Rear Hitch Frame Bar Wears from Implement

Product: Sand Pro/Infield Pro 3040 & 5040

August 20, 2008

Wear from contact

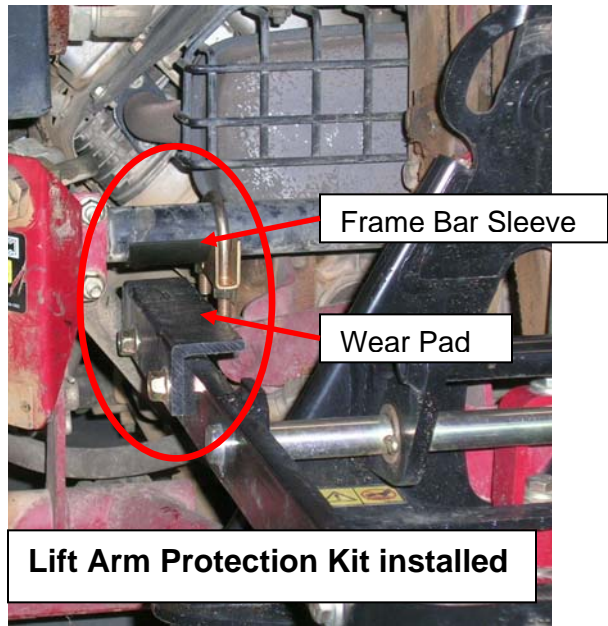
The rear Hitch Frame Bar can wear through from contact with the rear QAS attachment Lift Arm during lifting of the implement.

Machines equipped with either the rear Tooth Rake (08751), Rear Broom (08753) or Drag Mat Carrier (08756) should be fitted with a Lift Arm Protection Kit (115-5607). The Kit contains a high density plastic wear pad (for the Lift Arm) and a Frame Bar Sleeve (for the tractor if needed) that will prevent further damage to the Frame Bar.

If the rear QAS attachments (Tooth Rake, Rear Broom or Drag Mat Carrier) already have the plastic Wear Pad on the Lift Arm, then no additional action would be required.
